ATTACHMENT

**CAROLINA POWER & LIGHT COMPANY  
SHEARON HARRIS NUCLEAR PLANT  
UNITS 1, 2, 3 & 4**

**QUALITY ASSURANCE ORGANIZATION**

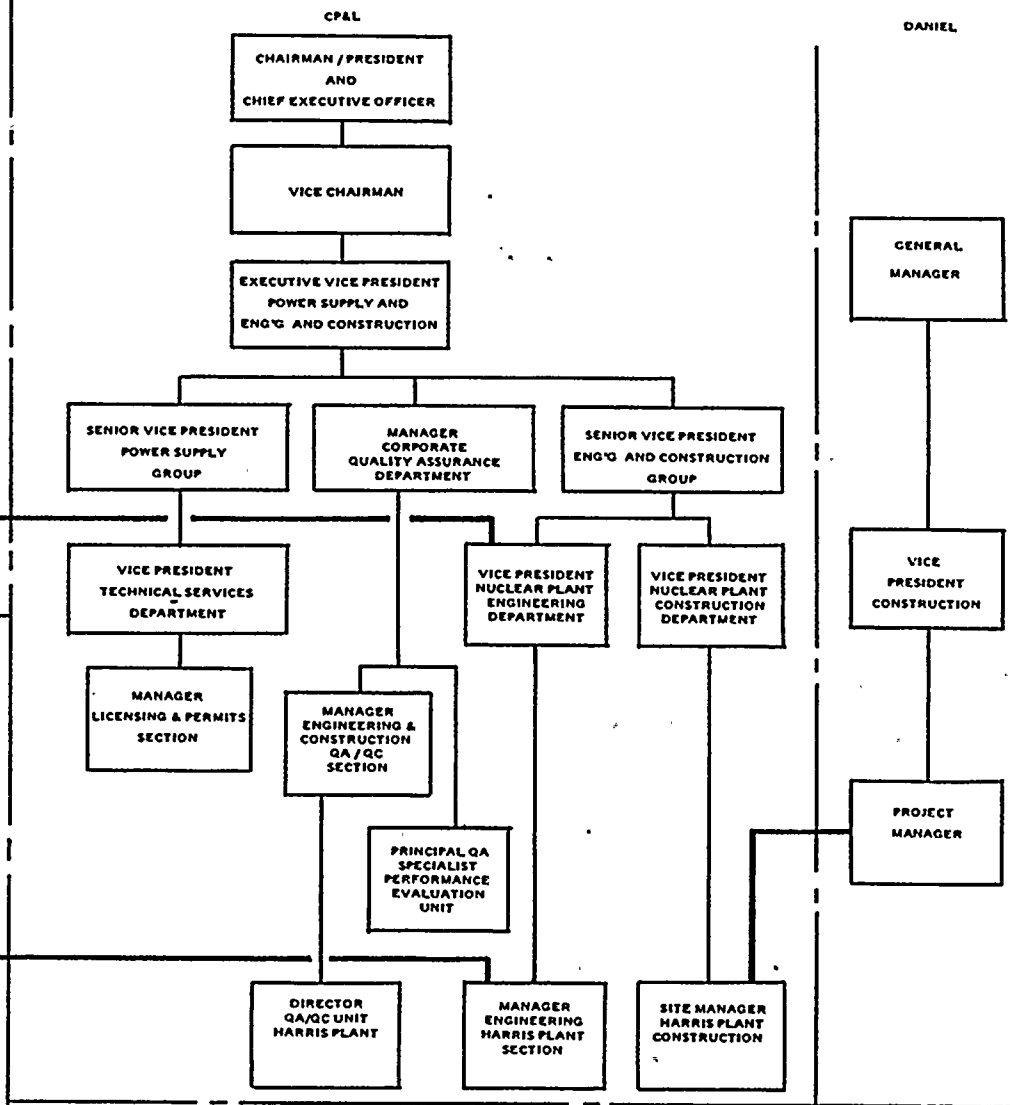
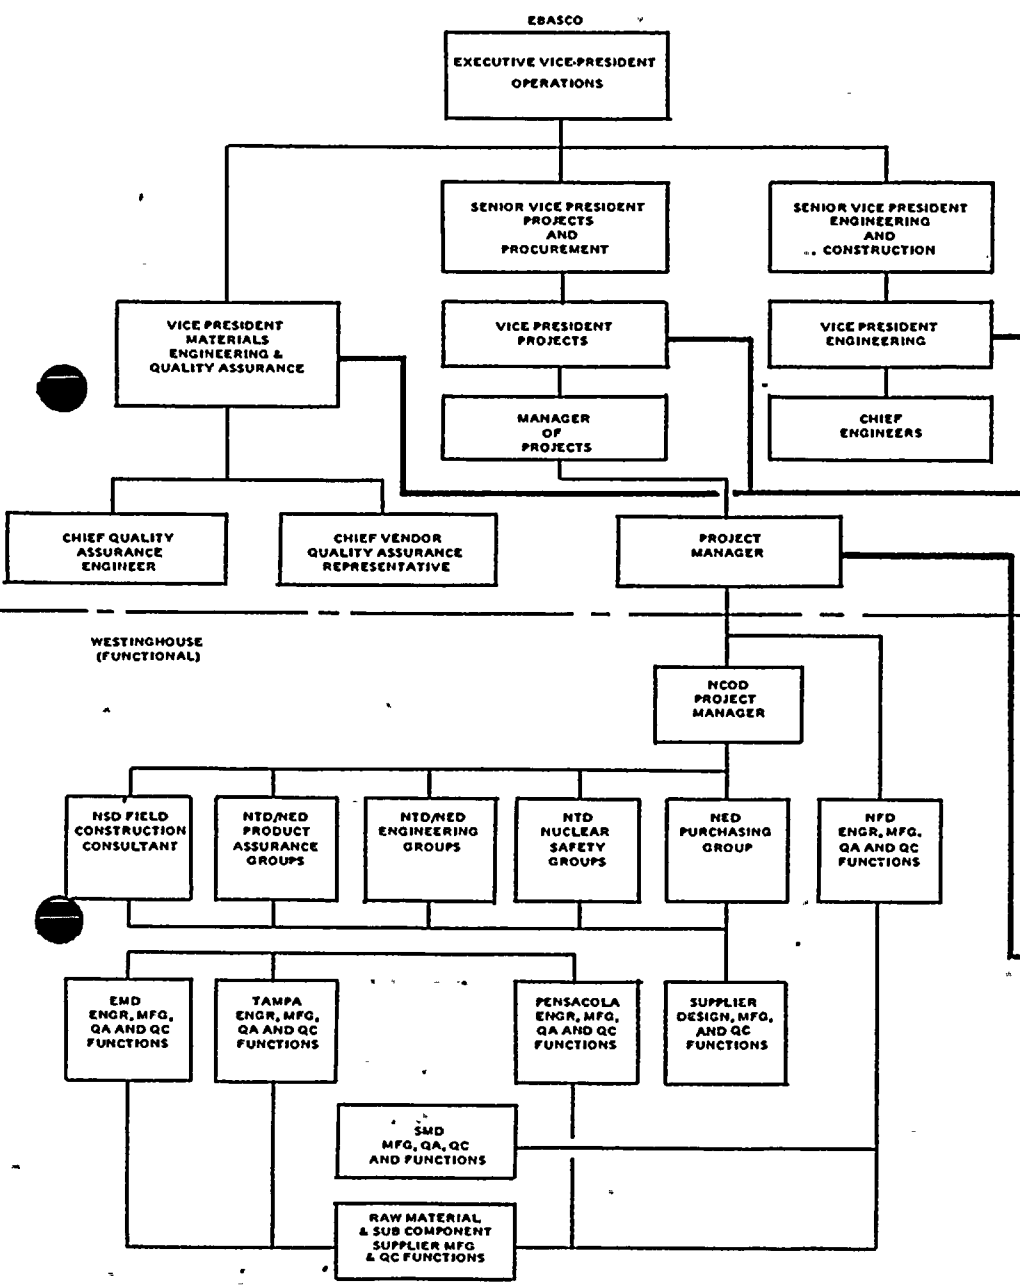
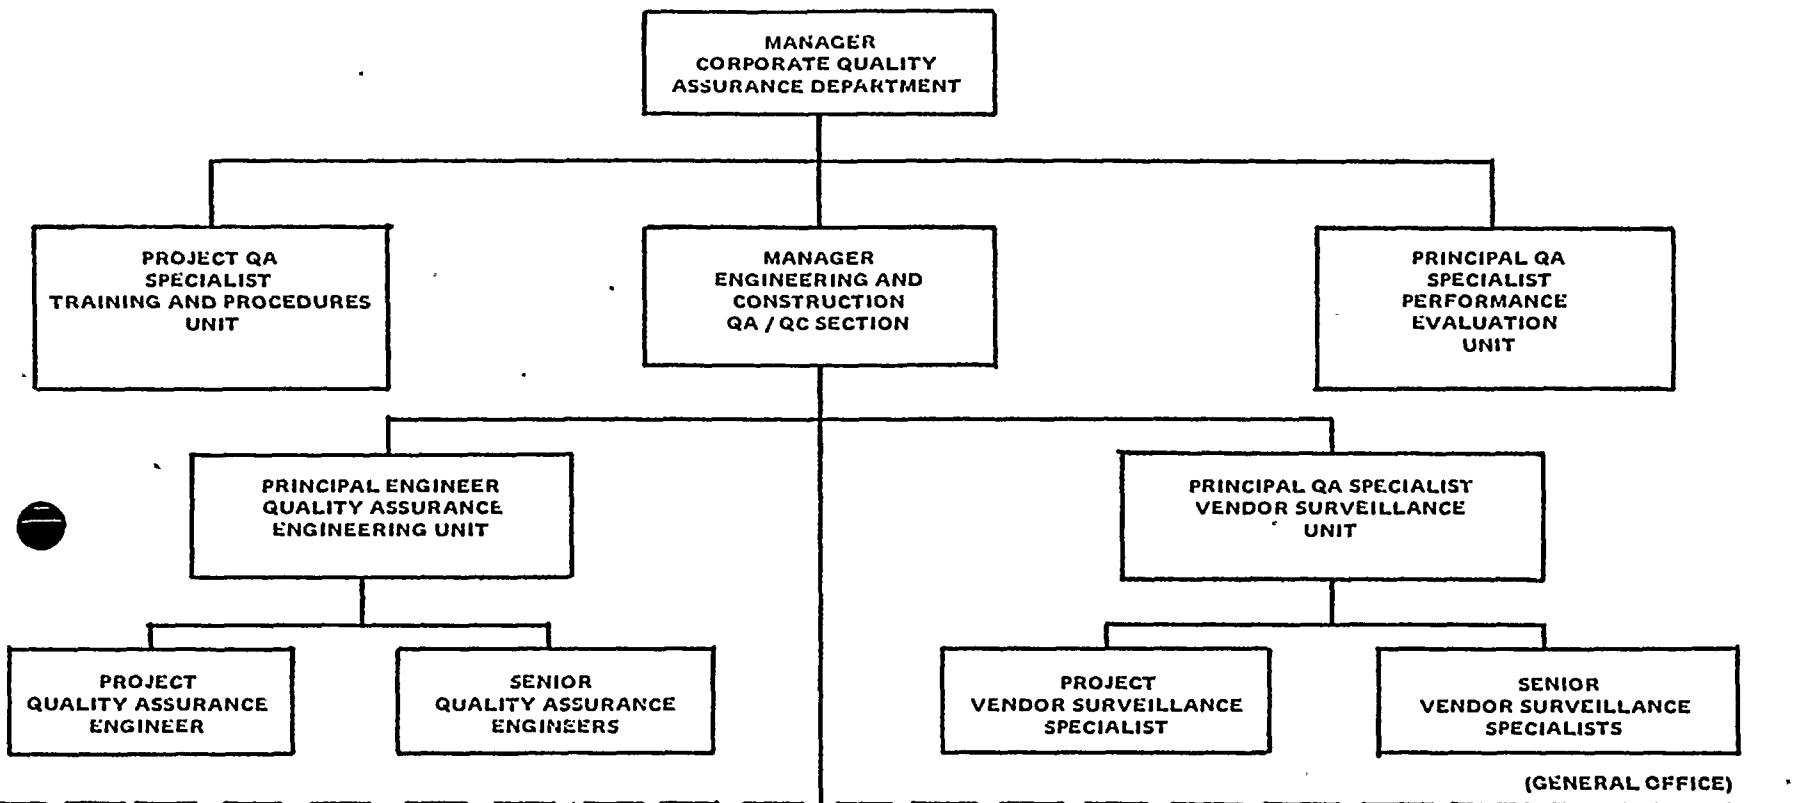
23. Reference in the first paragraph of page 1.8-4a of the PSAR to Executive Vice-President and Chief Operating Officer should be changed to read Vice-Chairman. Also the last sentence in this paragraph should be revised to read, "As shown by figure 1.8-1, the performance evaluation unit is independent from the Departments responsible for the engineering and construction of the plant."

37. The first line in section 1.8.5.18 on page 1.8-23j of the PSAR should be revised to read "CP&L's Corporate Quality Assurance Department, Performance Evaluation Unit is responsible for the planned . . ." Also the last sentence on this page should be revised as follows, "Internal audits will be conducted by Westinghouse and Ebasco of their Quality Assurance Programs."
38. The last sentence on page 1.8-42 of the PSAR should read, "Also vendor QA programs based on ASME Section VIII or ANSI B31.1 for boiler external piping will be acceptable to comply with ETSB 11-1 QA requirements."
39. The existing Table 1.8-4 in the PSAR should be replaced with the new attached table.
40. The existing figures 1.8-1 and 1.8-2 in the PSAR should be replaced with the new attached figures. Also figure 1.8-4 of the PSAR should be deleted.
